# Statement of Modification

Multi-Dwelling Housing  
5-7 Macpherson Street, Warriewood, NSW

Project 17-088  
March 2018  
Revision A

Figure 1: Proposed north elevation with outline of consented elevation indicated in dashed red line

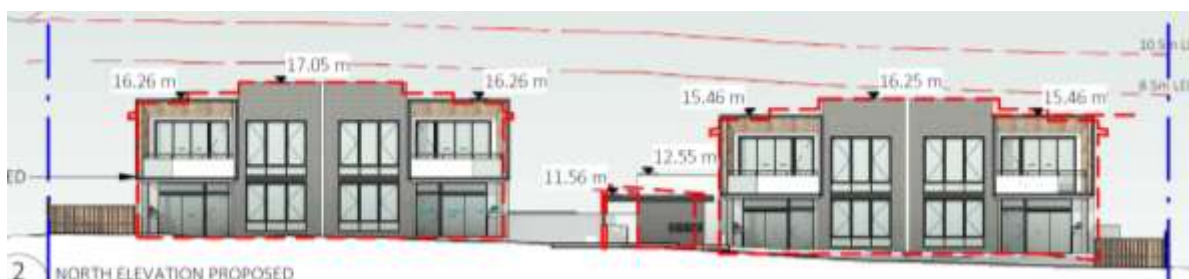
At the street front (Northern Elevation of Building A and B) the proposed modifications have reduced the maximum height of the proposed parapets. A comparison is provided in the following table.

In the consented development, the front façade included three levels as built form stepped down from the centre of each building towards the sides. The proposed modifications reduce the number of levels to two, eliminating the pyramid effect. The comparison drawing DA-808 includes a red dashed line to show how the modified design relates to the outline of the consented elevation.

Figure 2: Consented North Elevation with outline of proposed modified elevation indicated in dashed red line

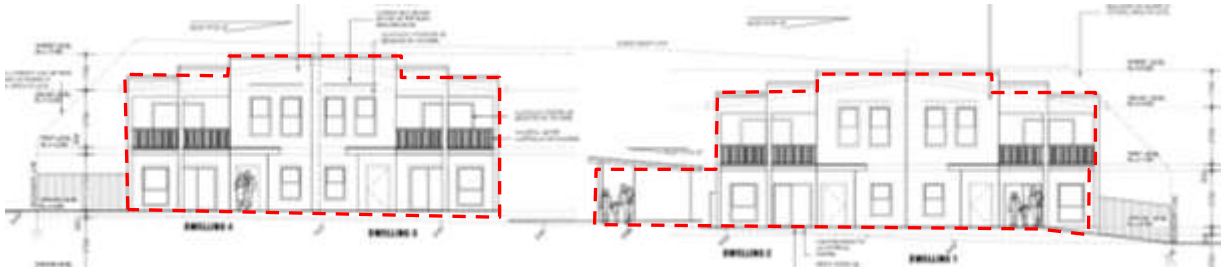
The outline of the proposed modified elevation overlaid on the consented elevation is provided in the figure below.

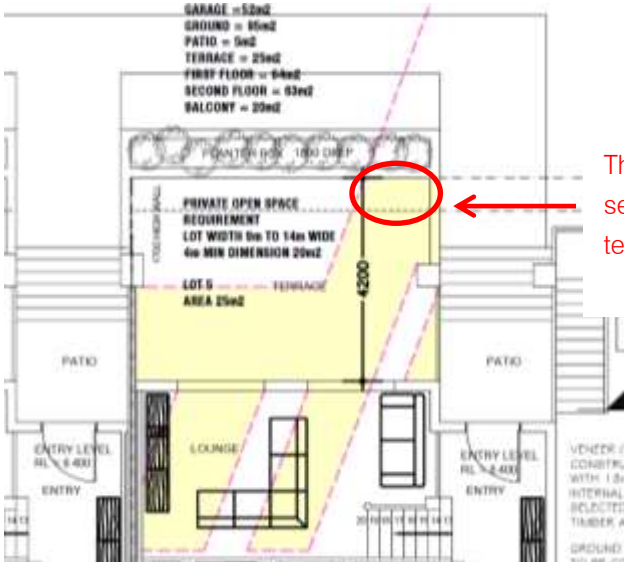
Topic	Council Comment	Response
	<p>the Application would become Integrated Development and a licence would be required from the NSW Office of Water.</p>	
<p><b>C6.4 The Road System and Pedestrian and Cyclist Network</b></p>	<p>The design of the amended basement carpark and the entry driveway (if applicable) would need to be undertaken in accordance with Part C6.4 of the DCP. In addition to the submitted plans, necessary information should include swept path diagrams demonstrating that the design of, and access to, all proposed car parking spaces would be in accordance with Australian Standards.</p> <p><b>Note:</b> There are conditions within Development Consent No. N0248/16 which relate to the design of the basement carpark. As a result of the proposed changes, some of these conditions may become redundant and/or require modification, replacement and/or removal. It is suggested that the applicant carefully review the court consent and that the Statement of Environmental Effects identify if/where further</p>	<p>The proposed basement car park employs a 6.69 m aisle width which is sufficient for vehicle manoeuvring. It is consistent with the Australian Standard being greater than the 5.8 m required. The width of the garage entry, width of the entry driveway, width of the aisle and width of the parking spaces have not been altered by the proposed modification. Only the driveway grades have been changed to allow the garage aisle to not have a sloping grade. The new grades to the driveway satisfy the Australian Standard.</p> <p>The garage shall function the same in terms of manoeuvring as the consented application and thus swept paths are not deemed necessary in this circumstance.</p> <p>As per the conditions of consent a signal is to be provided when visitor spaces are occupied.</p> <p>The proposed modifications do not change the total number of car parking spaces proposed. We are unaware that there are any conditions of consent as set out in the Notice of Orders Made for Case 2016/00252260 dated 19 January 2017 which require modification except for the substitution of the relevant drawing listed Under Annexure A.</p>
